IC Corporation

SAFETY RECALL 05505

April 2005

Recall Campaign # 05505 & SUBJECT (Engine Cover Retention Cable)

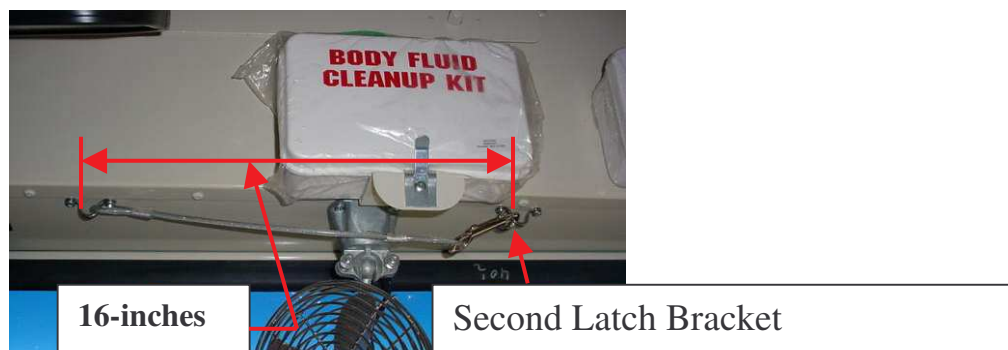
During pre-trip inspection or engine service, the engine cover lid can be opened until it leans against the instrument panel. There is no latching device to keep the lid open. When it is in the open position, the lid is slightly over center and can close if bumped, or if the bus is on a slight incline.

Without a retention device, when the engine cover lid is in the open position it can close without warning resulting in possible personal injury.

1. Mark the location of the first hole for the first latch bracket 4-inches to the right of the windshield center bar. Using the bracket as a template, align the bracket with the flange of the bulkhead to mark the location of the second hole. **Slip one end of the cable onto the bracket before attaching the bracket to the bus body.** Attach the bracket using the screws included in the kit. The picture below shows the result.
